VEHICLE SAFETY DEFECT  
INITIAL INFORMATION REPORT  
348 SPIDER PASSIVE RESTRAINT SEAT BELT SYSTEM  
RECALL No. 164

**RECALL CAMPAIGN NO. 164**

**SUBJECT :** Recall Campaign No. 164

### INSTRUCTIONS FOR THE PASSIVE RESTRAINT SEAT BELT SYSTEM REPLACEMENT

FIGURE A

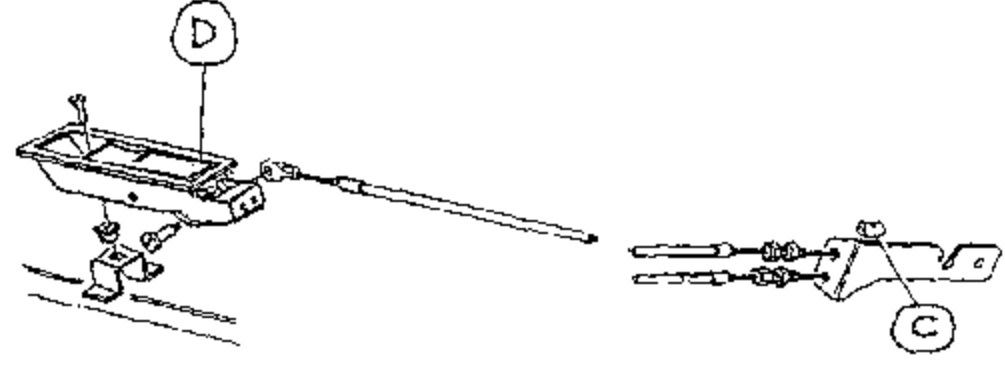
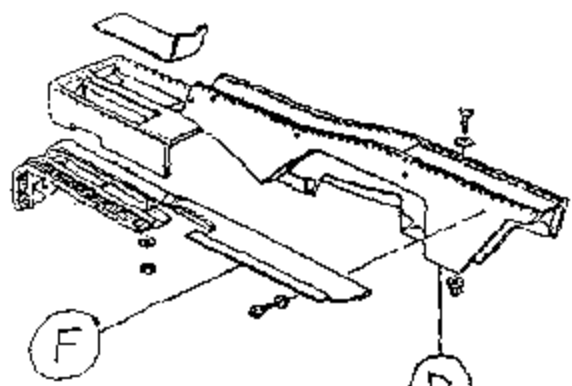
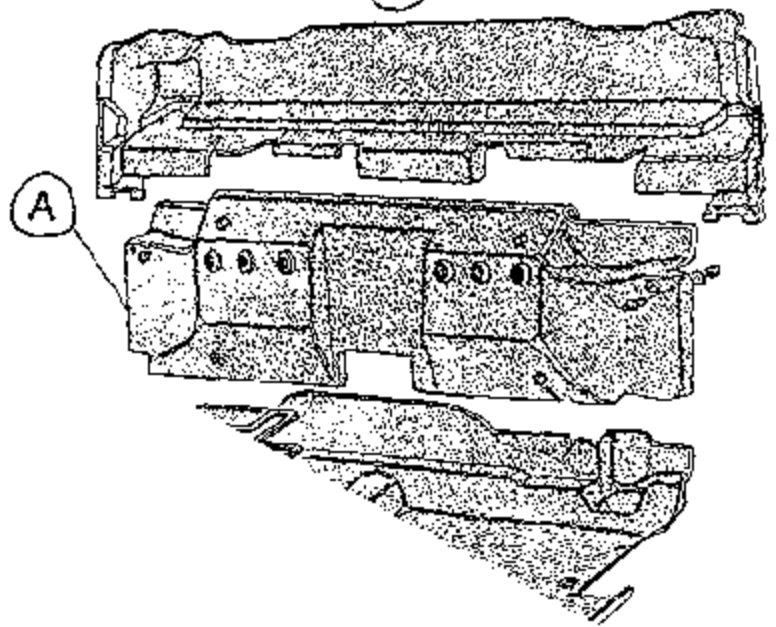
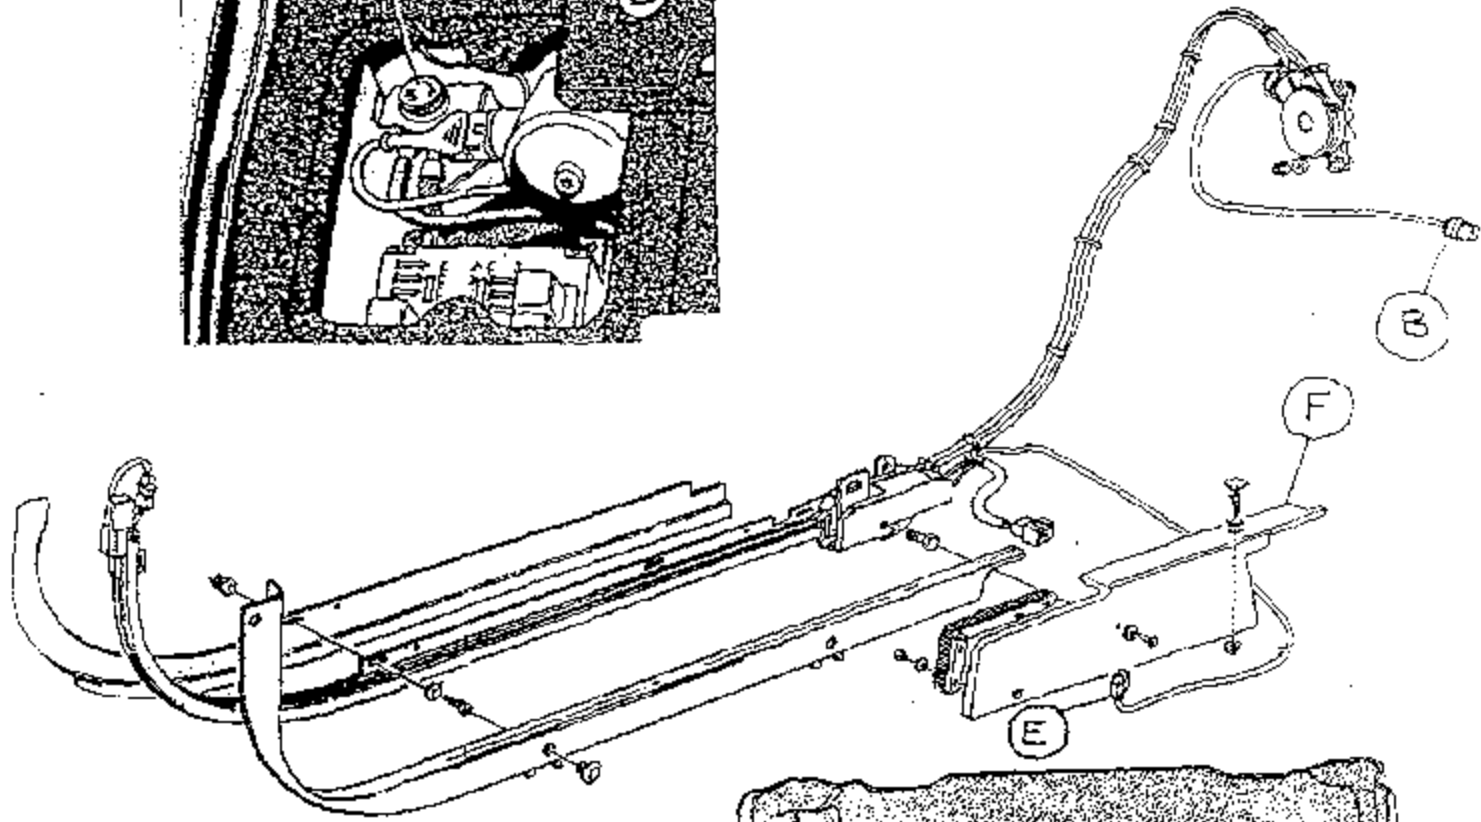
- 1) Turn the ignition key on, close the doors allowing the seat belt sliders to return to the "B" station. Turn the key off and turn off master switch in front trunk. ( Item "M" under the removable cover item "L")

- 2) Remove both driver and passenger seats being careful to disconnect the sensor plugs. (item "E" underneath the seats)
- 3) Remove the rear panel (item "A") and unplug the tape motor (item "B") from the chassis harness and remove the tape motor securing nuts.

- 4) Unscrew the cable clamp (item "C") at the rear deck lid latch.
- 5) Unscrew the trim screws to allow removal of the trim pieces which cover the seat belt rails.

- 6) Unscrew the trim panel around the rear deck lid release handle (item "D") and lift and slide the panel forward to expose the "B" station main securing bolt. The passenger side main securing bolt is exposed when the trim panel (item "F") is removed.

- 7) Remove the additional securing screws from both left and right rails and detach the protection plates from the outer edge of the rails.

**NOTE: IT IS EXTREMELY IMPORTANT THAT THESE PROTECTION PLATES ARE RE-ATTACHED TO THE NEW UPDATED RAILS. FAILURE TO INSTALL THE PROTECT PLATES WILL ALLOW THE INTERIOR CARPET TO INTERFERE WITH THE TRAVEL OF THE SLIDER MECHANISM.**

- 8) Install the updated seat belt rails making sure that proper clearance exists. Install the tape motors with new grommets.

**NOTE: IT IS EXTREMELY IMPORTANT NOT TO TWIST THE TAPE FROM THE RAIL TO THE MOTOR. THE UPPER SURFACE OF THE TAPE SHIELD SHOULD REMAIN ON THE TOP THROUGHOUT THE INSTALLATION.**

- 9) Re-connect the electrical plugs.
- 10) Re-install the trim pieces item "F"

**NOTE: IT IS EXTREMELY IMPORTANT TO SECURE THEM AS FAR TO THE REAR AS POSSIBLE TO AVOID CONTACT WITH THE SLIDER WHEN IT IS IN THE "B" STATION.**

**FIGURE B**

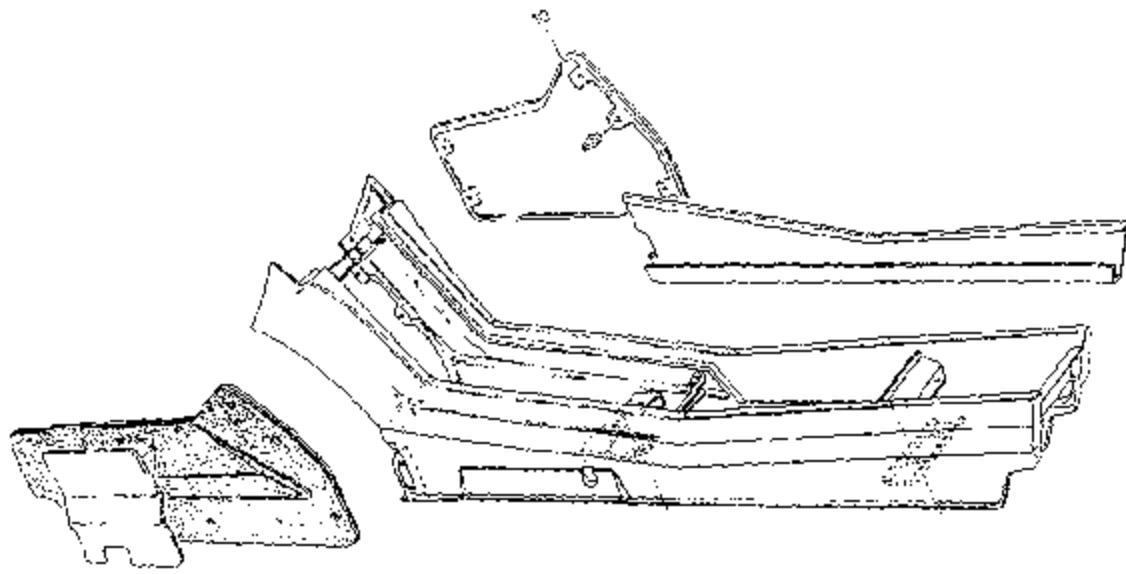
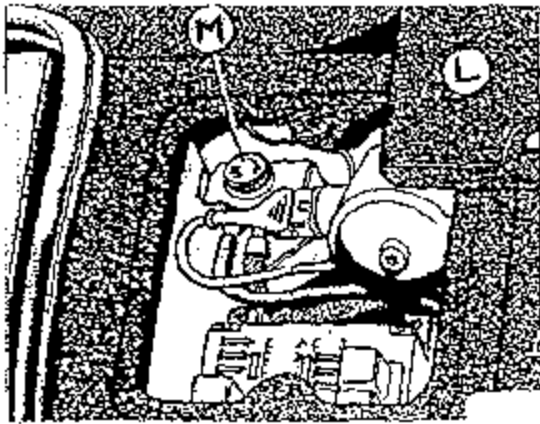
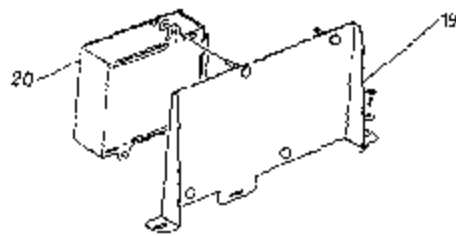
13) Remove right side center console trim panel (item "10" Figure "B") and replace both seat belt control units which are bolted to item "19" in figure "B".

14) Re-install right side center console trim panel item "10".
